North Tower Design Update

Sydney Metro Martin Place Over Station Development Design Review Panel DRP #02

1 May 2018

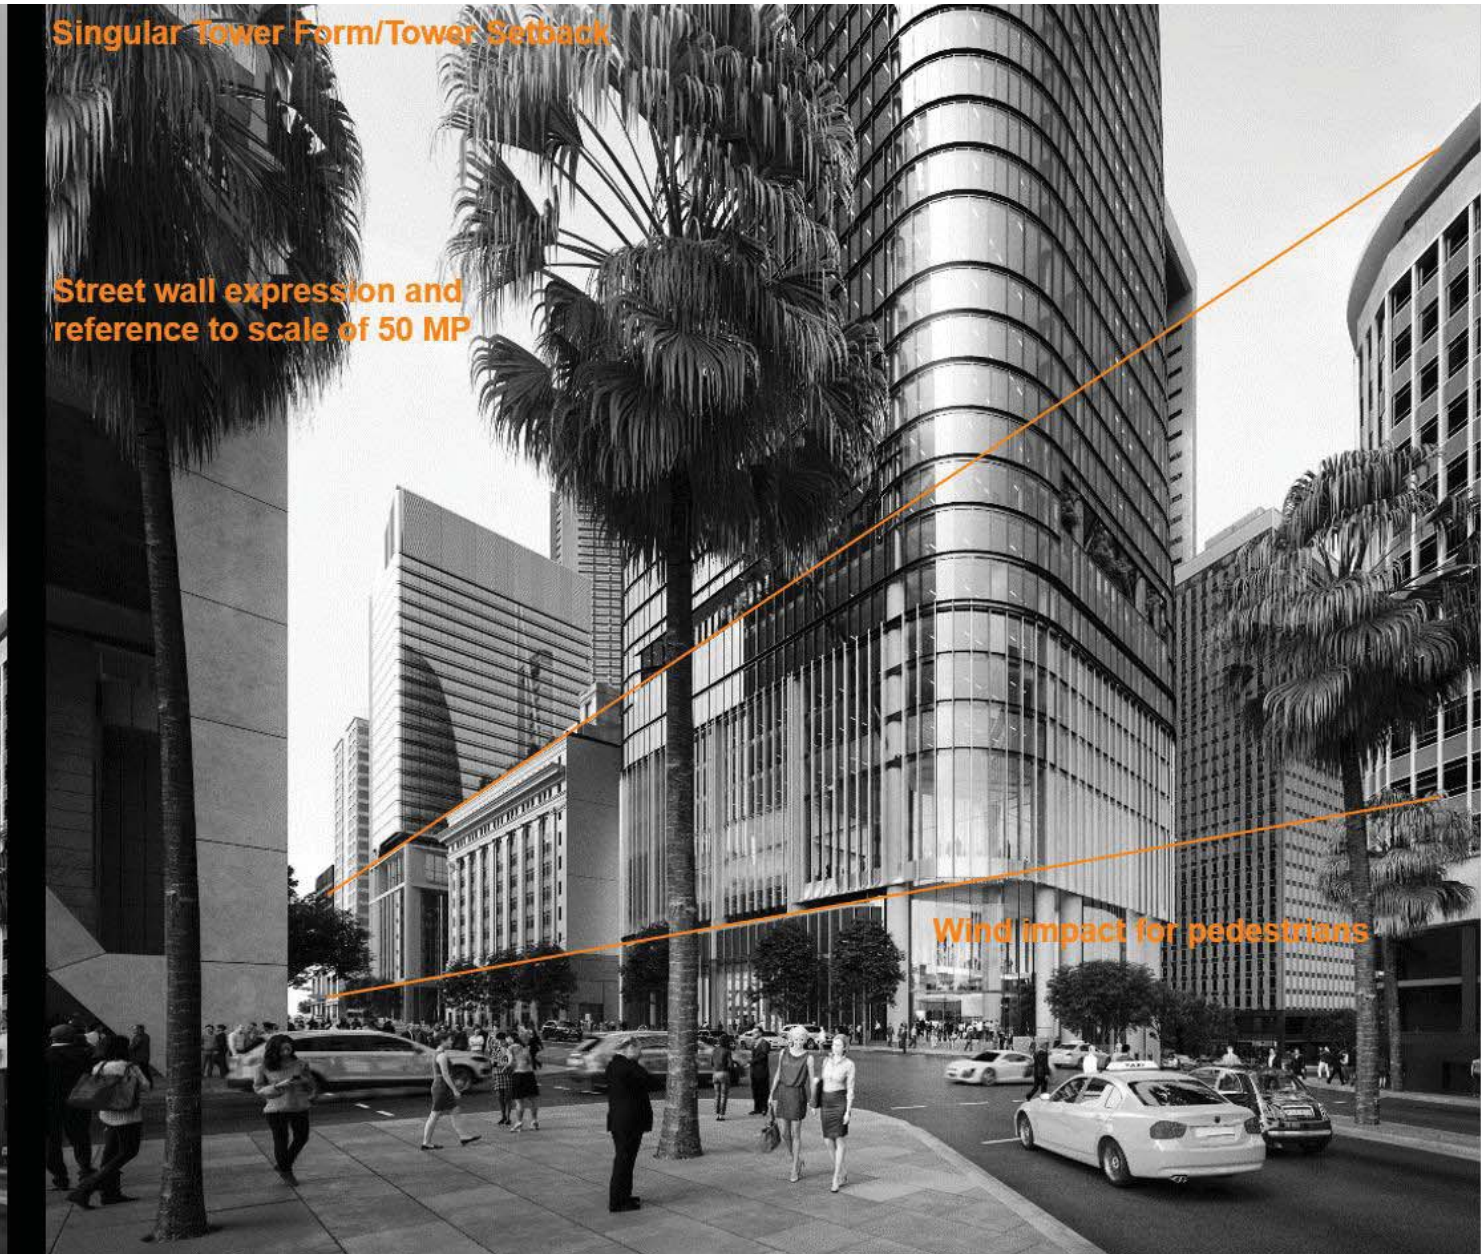
2017 DRP Open Items

Singular Tower Form/Tower Setback

Street wall expression and
reference to scale of 50 MP

Wind impact for pedestrians

JPW has commenced working through the Sydney Metro DRP feedback for the North Tower

North Tower Design Update (continued)

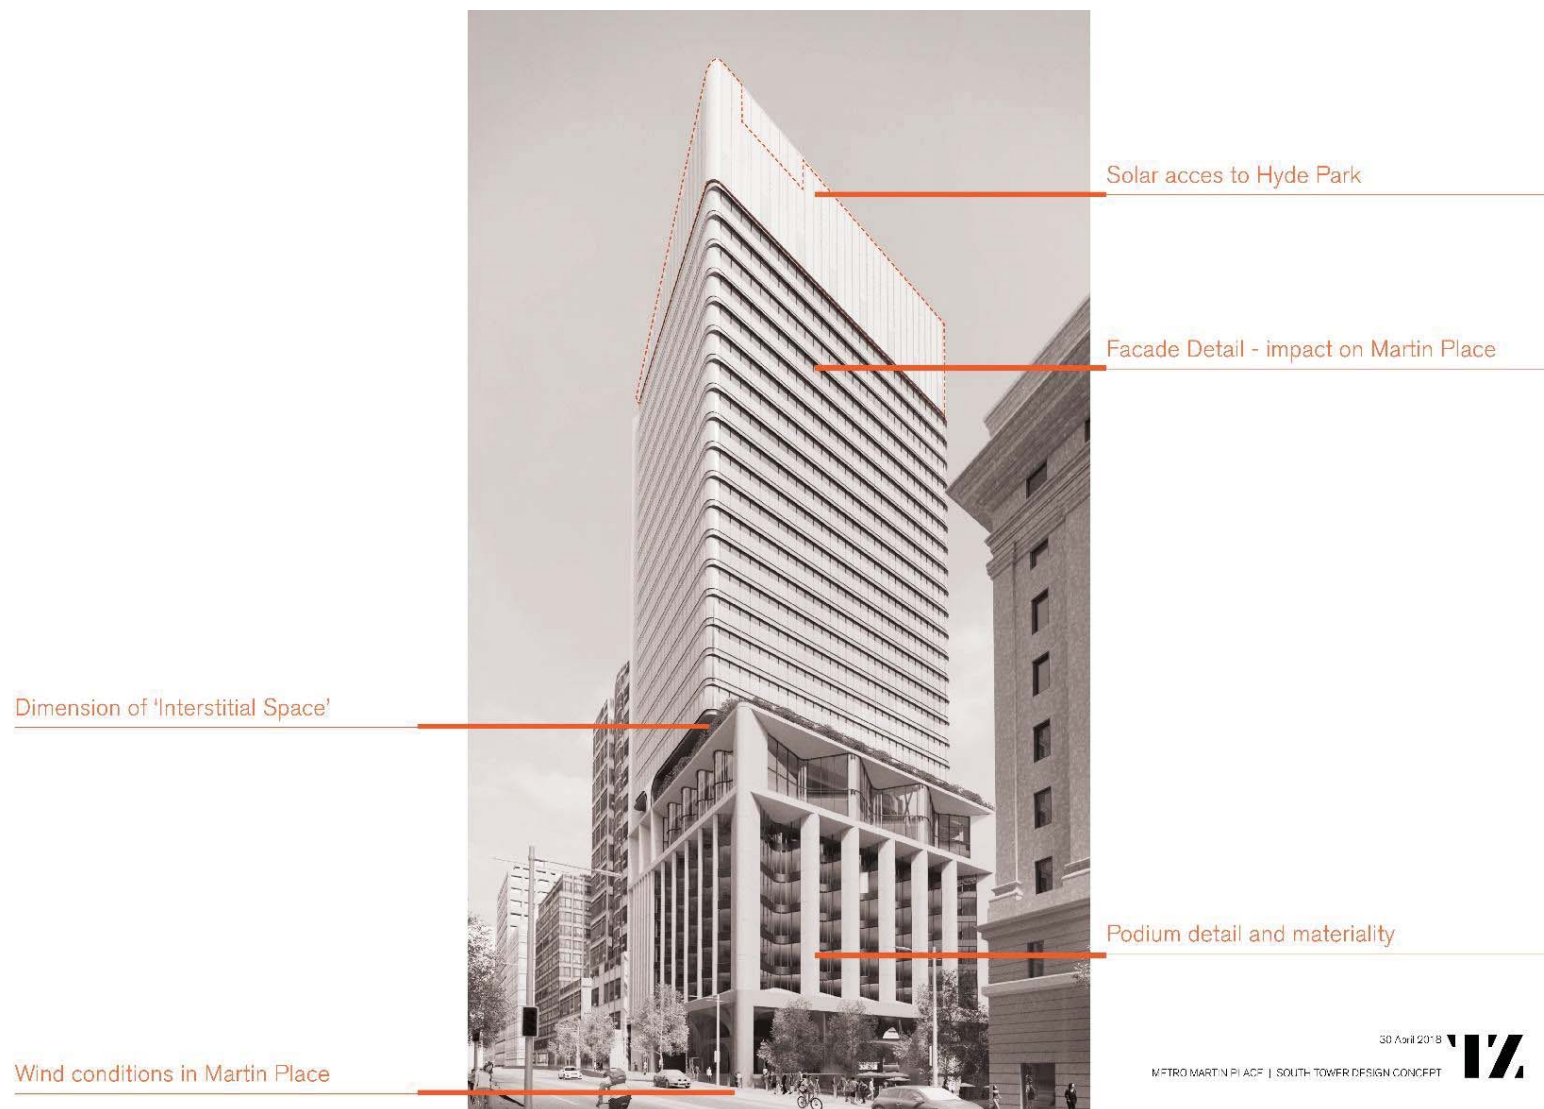
Ensure SSDA Max GFA is balanced with building forms that are proportionately elegant and exhibit appropriate façade articulation

The facades are to respond to the articulation, principal streetwall height or other key datum lines of 50MP, former Qantas House and the reverse podium of 8 Chifley and Deutsche bank

A new building tower and podium/base is to sensitively integrate (towards and at its southern extent) with the low scale of 50 MP and clearly articulate its street wall height on Castlereagh and Elizabeth Streets

A considered transition between the North Tower and 50MP is required, with the southern elevation of the North Tower being sensitively integrated with the form of 50MP

Zero setback for Hunter Street to align with towers to the east may be appropriate subject to achieving relevant public domain standards to use and activity

Metro DRP Open Points

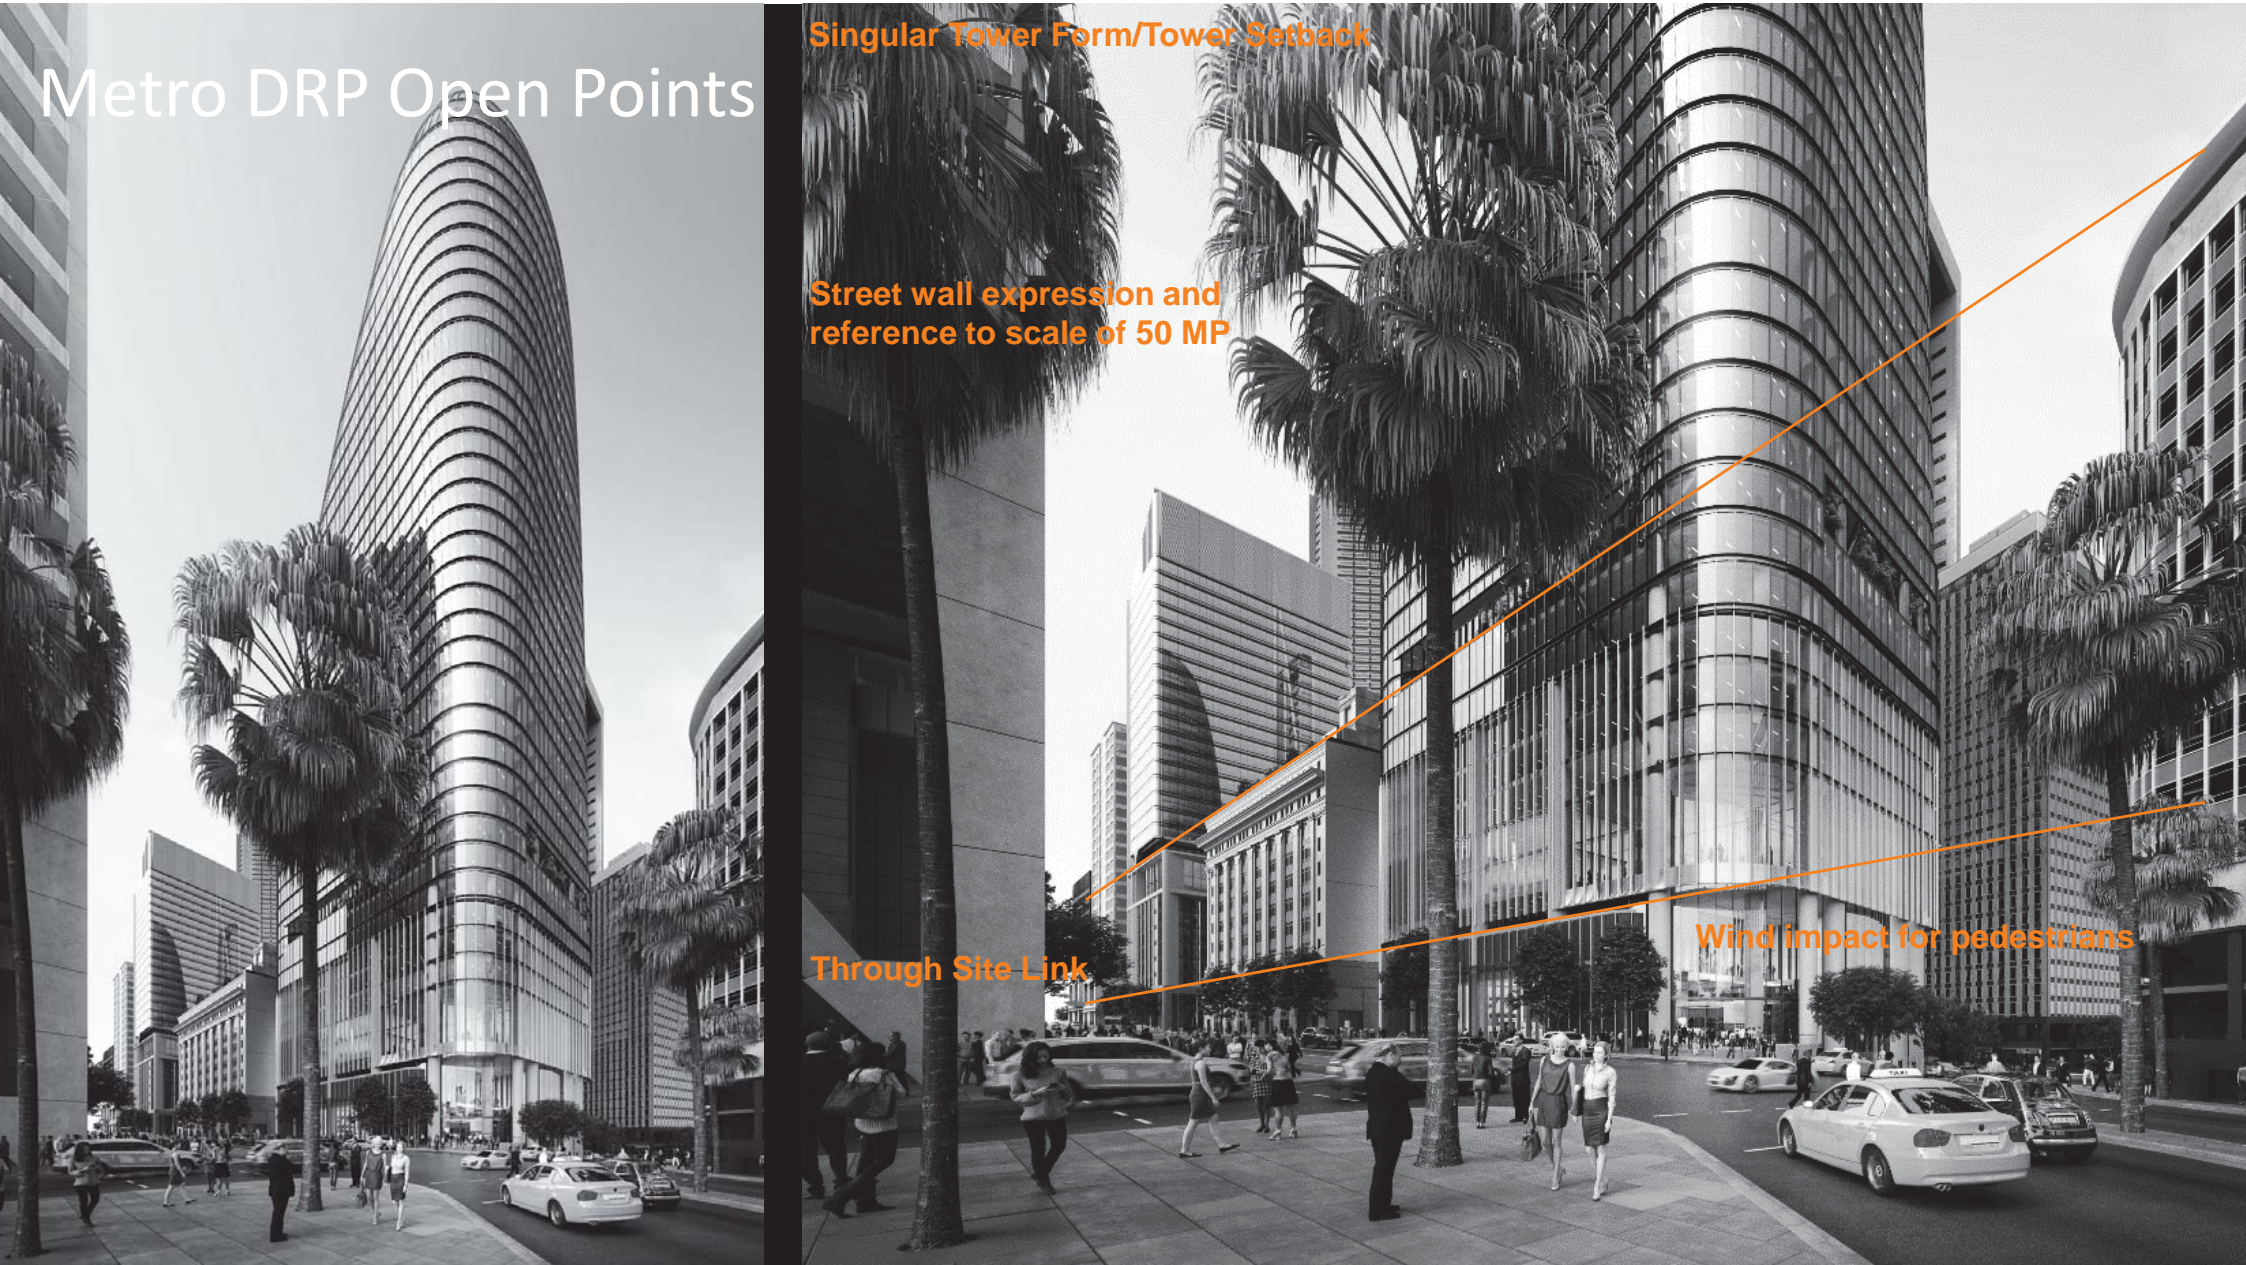
Singular Tower Form/Tower Setback

Street wall expression and
reference to scale of 50 MP

Through Site Link

Wind impact for pedestrians
